Lin
10/665,040

REMARKS

ANNOTATED MARKED-UP DRAWING

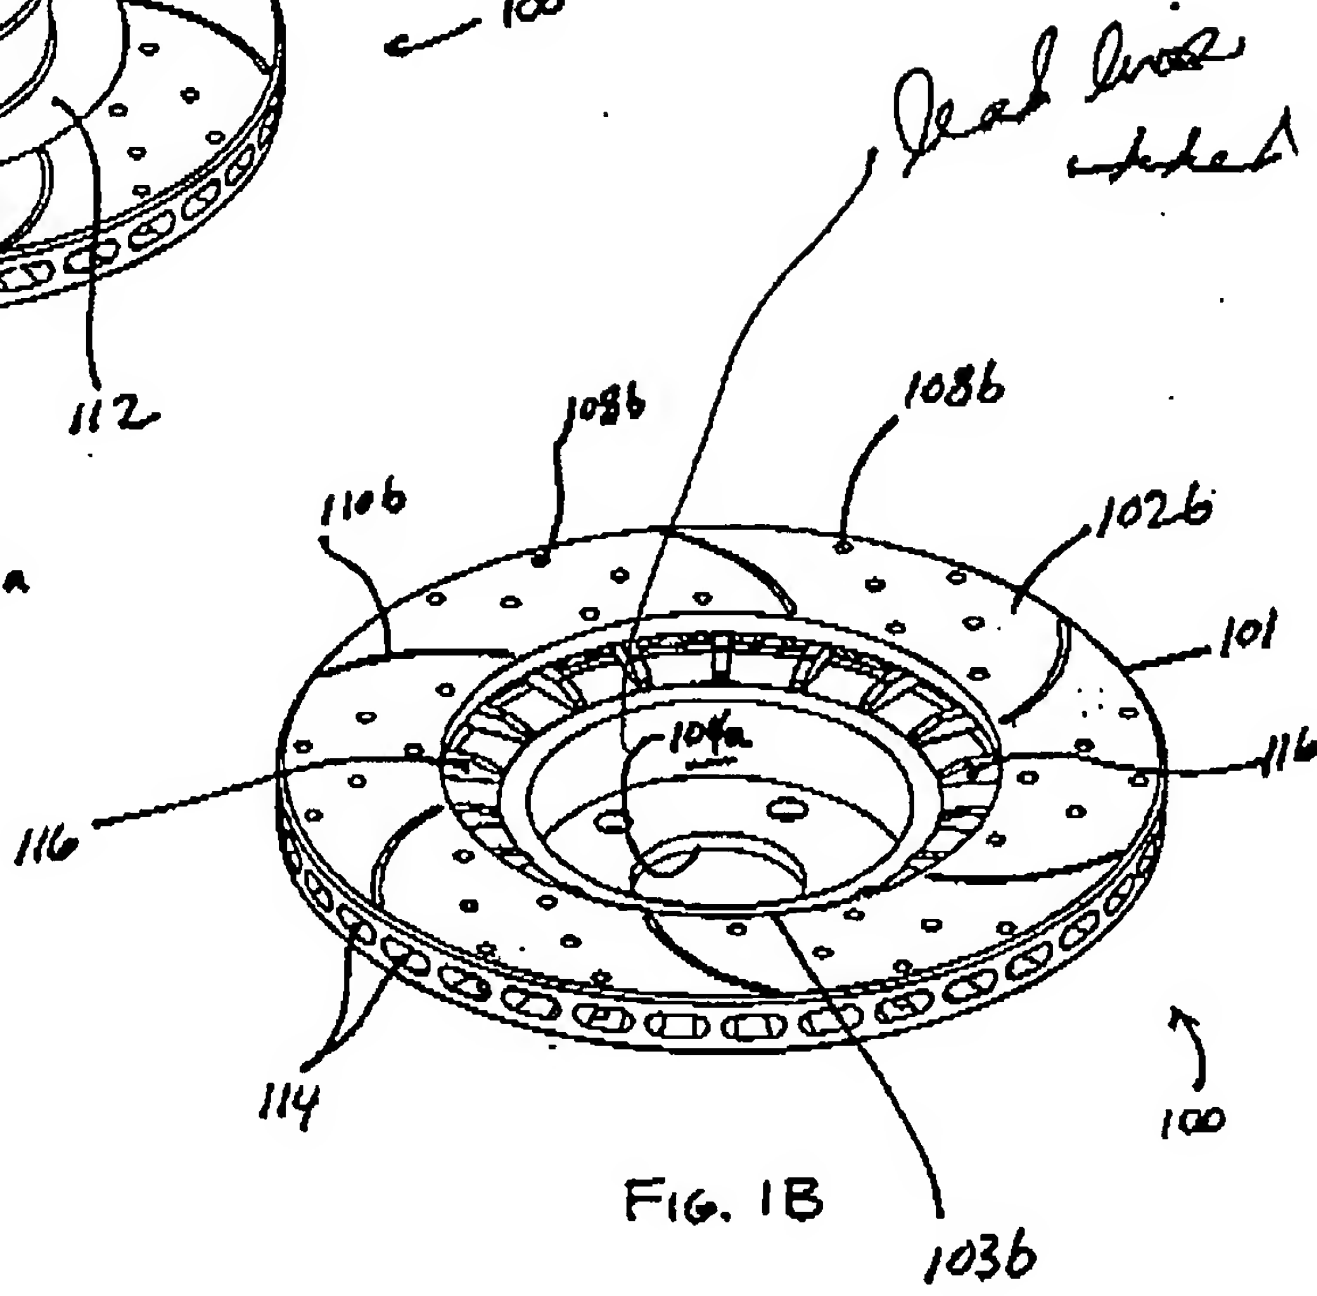
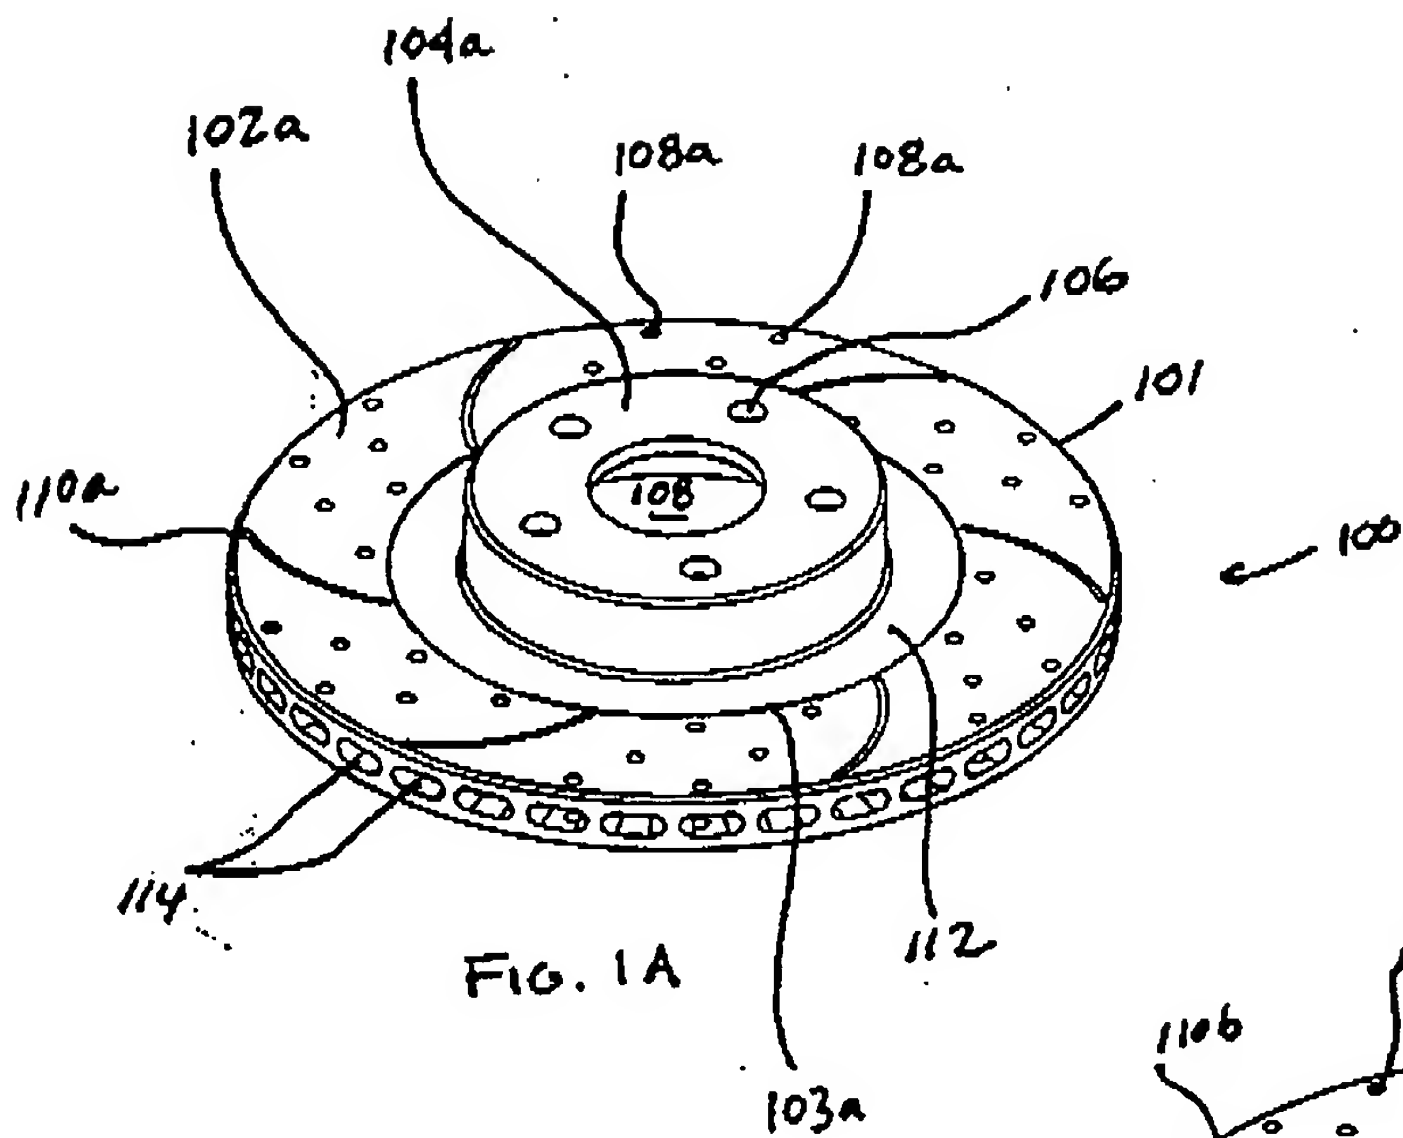
The drawings were objected to on the grounds that numeral "104a" in Fig. 1B lacks a lead line. Accompanying are a replacement sheet with the correction and an annotated version of the change.
